Sparrow Apparels Ltd. (Extension)

Structural Inspection Report

1. Building Information:

Observation-1: Lack of design documents. (ETP-Building# 5)

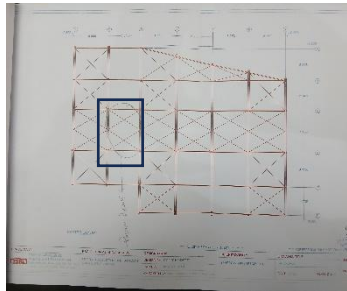
Description: As per BNBC, every building or structure designed shall have its design documents prepared following the provision of Section 1.9.1. The design document shall include a design report and a set of structural drawings, which shall be prepared in compliance with sections 1.9.1.1 and 1.9.1.2 as per BNBC.

At the time of inspection, design documents (design report, load plan, and adequate material test reports) were not available, which are required to be prepared in compliance with section 1.9.1 (part-6, BNBC).

Item No	Observation	Action Plan	Timeline
1.	Lack of design documents. (ETP-Building# 5)	The building engineer is required to prepare design documents (including design reports, material test reports, live load plan) in compliance with section 1.9.1 (part 6, BNBC).	within 6 weeks

Observation-3: Lack of design documents and lateral stability. (New warehouse shed)

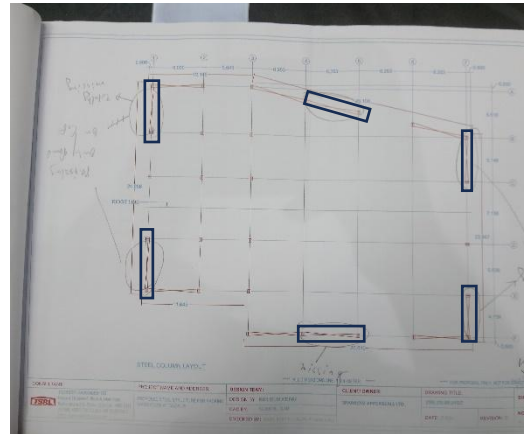
Missing horizontal
bracing in the marked
location

Missing vertical bracing in the marked
location

Description: Horizontal & Vertical bracing was found missing in the marked location. Also, no design documents were observed during the inspection. As per BNBC, every building or structure designed shall have its design documents prepared following the provision of Section 1.9.1. The design document shall include a design report and a set of structural drawings, which shall be prepared in compliance with sections 1.9.1.1 and 1.9.1.2 as per BNBC.

The building engineer is required to prepare an Engineering Assessment (EA) and check the lateral stability of the shed.

Observation-4: Mismatch in as-built drawings. (New warehouse shed)

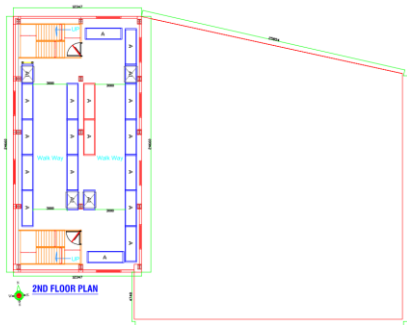
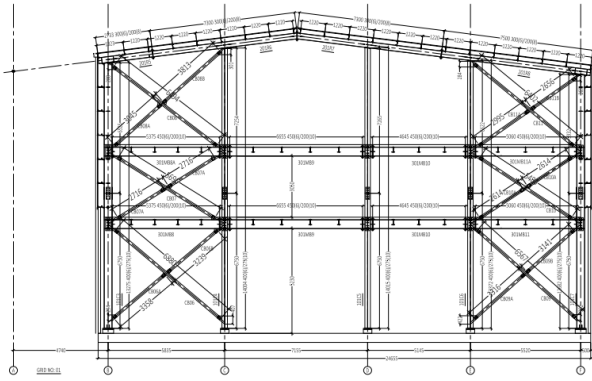
Description: Eccentric bracing found onsite drawings show concentric bracing, bracing size does not match the site condition, architectural drawing, strut orientation not match with the site condition.

Building engineer is required to survey the structure and prepare accurate as-built drawings.

Observation-6: Falling Hazard. (New warehouse shed)

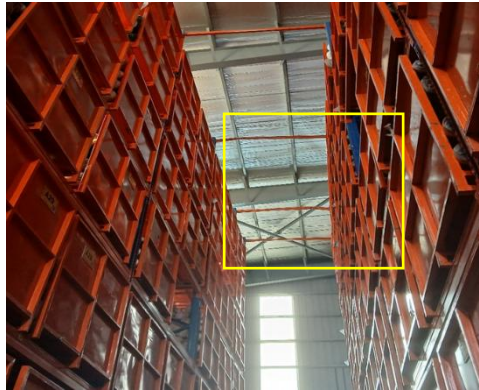
Description: No fall protection was provided on the window and the edge of the floor where a clear gap was found, which may cause a falling hazard. The factory is required to provide fall protection to avoid possible falling hazards.

8.	Falling Hazard. (New warehouse shed)	The factory is required to provide fall protection to avoid possible falling hazards.	within 6 weeks
9.	Gap in connection and poor joint detail (New warehouse shed)	Building engineer is required to repair the gap with a suitable method.	within 6 weeks

Observation-8: Damaged structural elements (New warehouse shed)

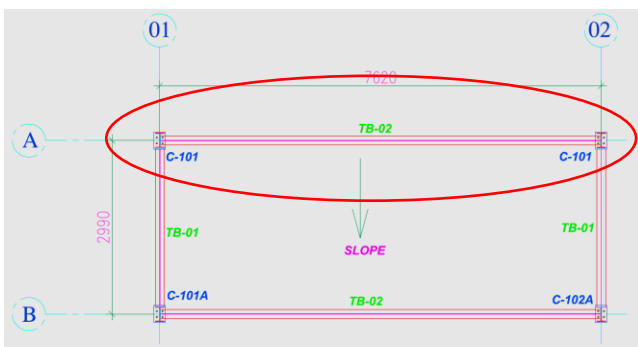
Description: Damage was observed on the braced elements of the racks. Building engineer is required to check the design of the braced elements and repair the elements with a suitable method.

10.		Also, check the connection adequacy as part of EA.	within 6 weeks
11.	Damaged structural elements. (New warehouse shed)	Building engineer is required to check the design of the braced elements and repair the elements with a suitable method.	within 6 weeks

Observation-9: Mismatch in as-built drawing. (Fabric Segregation Shed)

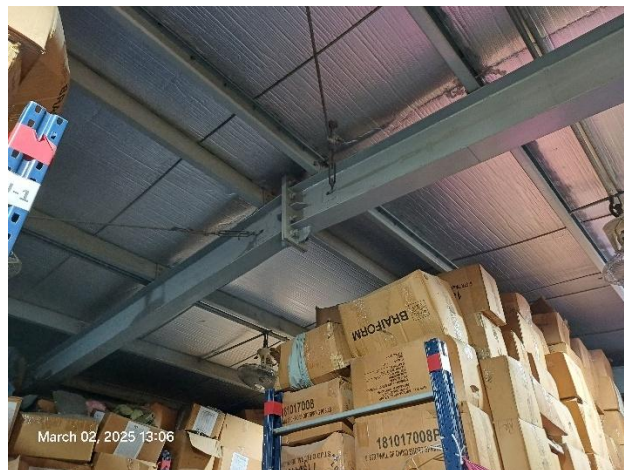
Description: As per the as-built drawing, a tie beam is missing on site. The building engineer is required to update the as-built drawing and submit it to RSC.

12.	Mismatch in the as-built drawing. (Fabric Segregation Shed)	The building engineer is required to update the as-built drawing and submit it to RSC.	within 6 weeks

Observation-11: Missing bolts. (Fabric Segregation Shed)

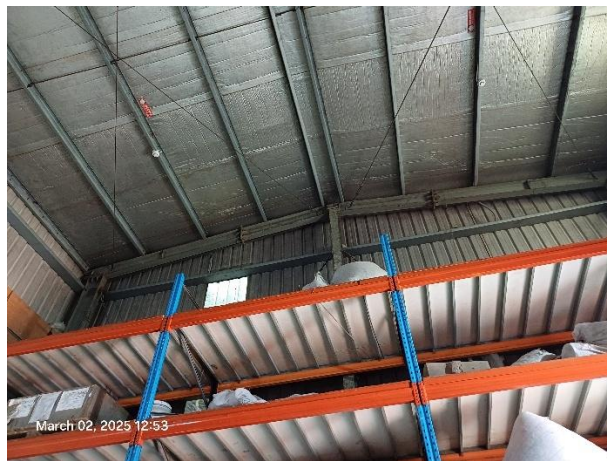
Description: Missing bolts were observed in some locations of Fabric Segregation Shed. The building engineer is required to install all missing bolts in all locations.

14.		Carry out the suggested remedial work if required.	within 6 months
15.	Missing bolts. (Fabric Segregation Shed)	The building engineer is required to install all missing bolts in all locations.	within 6 weeks

Observation-12: Lack of design documents and absence of lateral stability system. (Washing Store Shed)

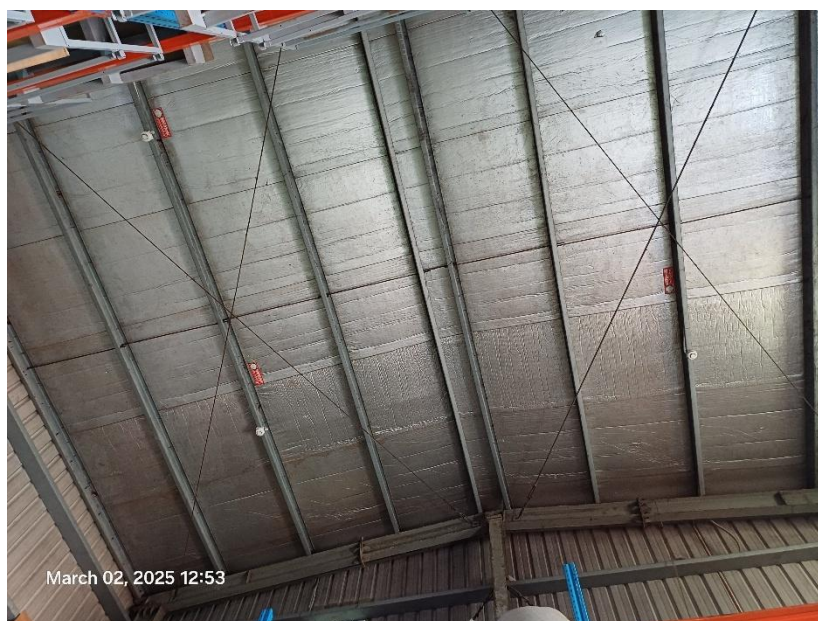
Description: The roof of the structure has no obvious lateral stability system (strut). Also, no design documents were observed during the inspection.

At the time of inspection, design documents (design report, load plan and material test reports) were not available, which are required to be prepared in compliance with section 1.9.1 (part-6, BNBC).

16.	Lack of design documents and incomplete lateral stability system. (Washing Store Shed)	The building engineer is required to prepare design documents (including design reports, material test reports, live load plan and accurate as-built drawings) in compliance with section 1.9.1 (part 6, BNBC). Check the lateral stability of the structure.	within 6 weeks
